**1958 Agreement – Consideration of draft amendments
to existing Regulations submitted by GRSP**

Proposal for Supplement 1 to Regulation No. [135] (Pole Side Impact (PSI))

Submitted by the Working Party on Passive Safety *

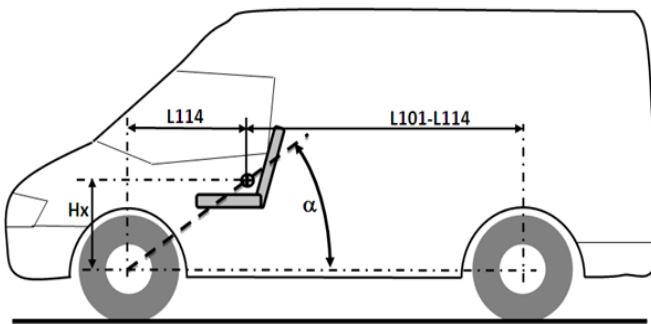
Paragraph 1.1., amend to read:

"1.1. This Regulation applies to:

- (a) Category M₁ vehicles with a gross vehicle mass of up to 3500 kg; and
- (b) Category N₁ vehicles where the acute angle alpha (α), measured between a horizontal plane passing through the centre of the front axle and an angular transverse plane passing through the centre of the front axle and the R-point of the driver's seat, as illustrated below, is less than 22.0 degrees; or the ratio between the distance from the driver's R-point to the centre of the rear axle (L101-L114) and the centre of the front axle and the driver's R-point (L114) is less than 1.30.²
